## SOP 441 – Prysmian 400kV Cable Terminations – update to RMZ dimensions

This Express supersedes Safety Express EXP-10-579, published in February 2025, which is now withdrawn. The revision in this Express is to the dimensions of the RMZ noted below, from 25m to 30m at Hunterston East.

Hunterston East Updated RMZ as per OPSAF-04-026

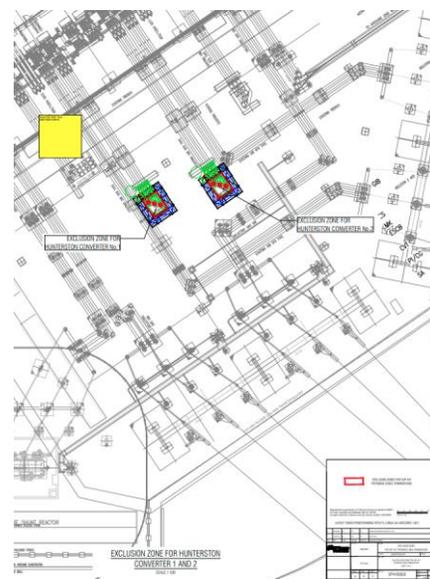
SPEN have taken the decision to update the Risk Management Zone (RMZ). No personnel are to be within a minimum distance of 30m at Hunterston East and 25m at Hunterston Converter Station around all matching cable termination types.
